KANSAS GAS AND ELECTRIC COMPANY

KMLNRC 82-242
Re: Docket No. STN 50-482
Ref: NUREG-0881, Wolf Creek Safety
Evaluation Report

Transmitted herewith is a revised response to NRC Question 241.15WC. The purpose of this revised response is to provide information needed to resolve Confirmatory Item A-2 (Main Dam Seepage) identified in the Referenced document. This information will be formally incorporated into the Wolf Creek Generating Station, Unit No. 1, Final Safety Analysis Report in Revision 10. This information is hereby incorporated into the Wolf Creek Generating Station, Unit No. 1, Operating License Application.

**FIGURE 241.15-2
LOCATION OF SEEPAGE
OBSERVATIONS AT MAIN DAM**

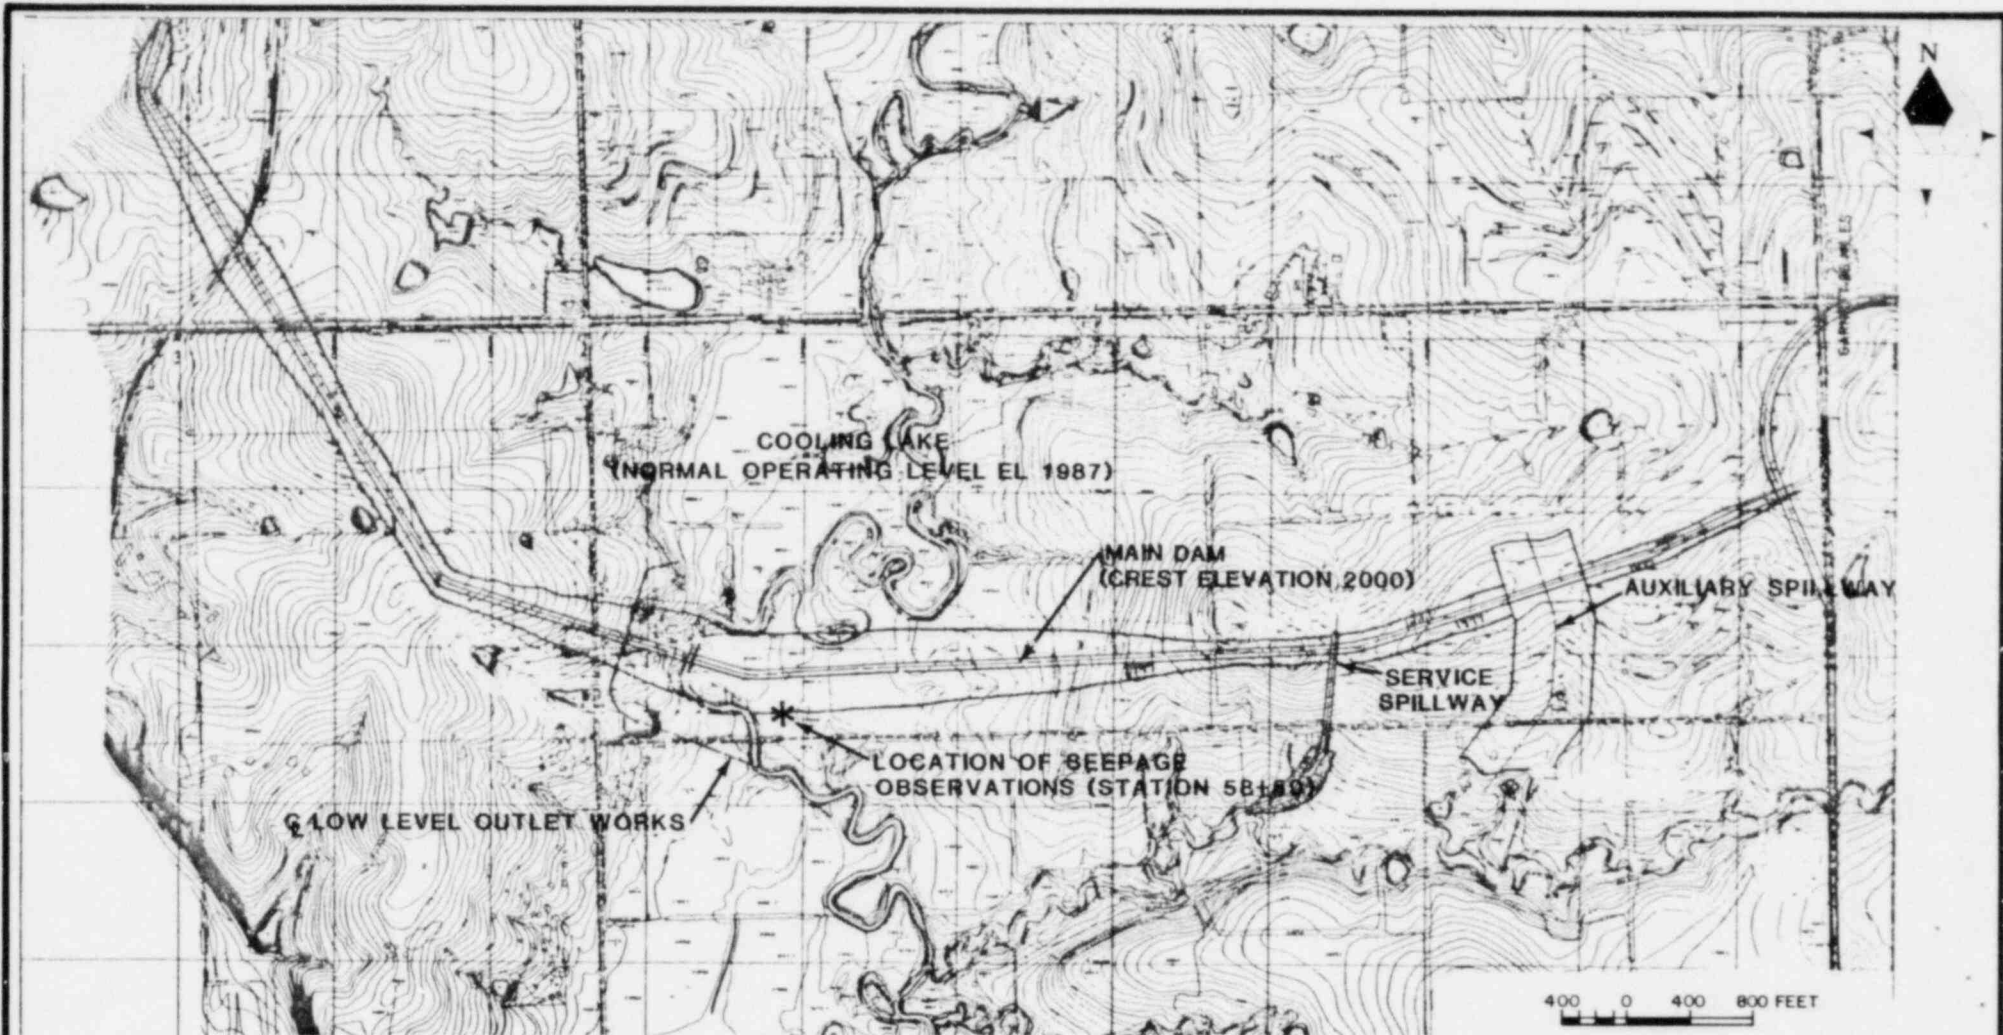
Data collected to date on the observed seepage on the downstream toe of the Main Dam at Station 58+50 are presented in Table 241.15-6. Data on the cooling lake elevations on the date of each seepage observation are also shown on this table. The location of the seepage observations is shown on Figure 241.15-2. The seepage observations made to date

**FIGURE 241.15-3
OBSERVED SEEPAGE AND
PRECIPITATION DATA**

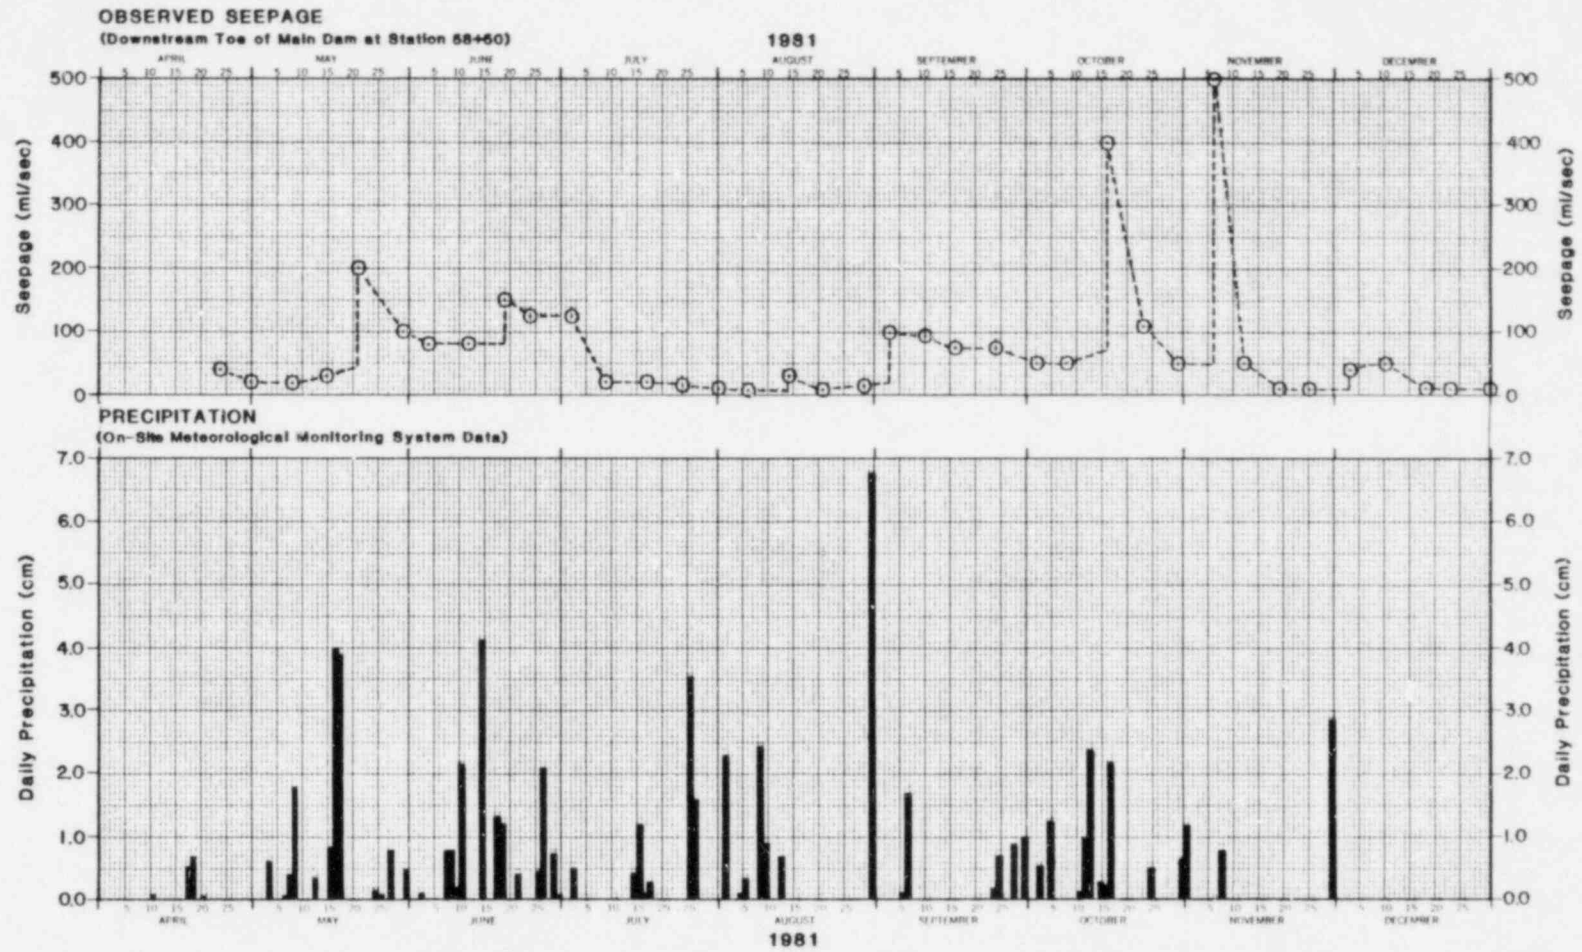
The observed seepage rate data collected to date indicate a wide range of flow rates ranging from 5 milliliters per second (ml/sec) to 1500 ml/sec. The majority of the observations, however, indicate seepage flow rates of less than 100 ml/sec. The higher flow rates which occasionally occur appear to be related to periods of precipitation which occurred prior to observation dates, and are not considered to represent increases in seepage of water from the cooling lake through the Main Dam embankment, but rather infiltration through the toe drain. This is supported by the fact that peaks in the observed seepage rates are always followed by a return to a substantially lower rate on later observations. In order to illustrate the relationship between precipitation and fluctuations in the observed seepage flow rates, the two sets of data are graphically compared on Figure 241.15-3. This figure represents the period through December 1981 for which digitized precipitation data are available from the onsite meteorological monitoring system. Although digitized precipitation data are not available for 1982, inspection reports indicate that rain runoff contributed to the occasional peak flow rates observed in 1982.

The data collected to date indicates that observed seepage is well within the seepage rates previously estimated for the Main Dam. Based on the permeability values of the materials used in the construction of the Main Dam embankment, a seepage rate of 0.6×10^{-5} cubic feet per second (.16992 ml/sec) per foot of Main
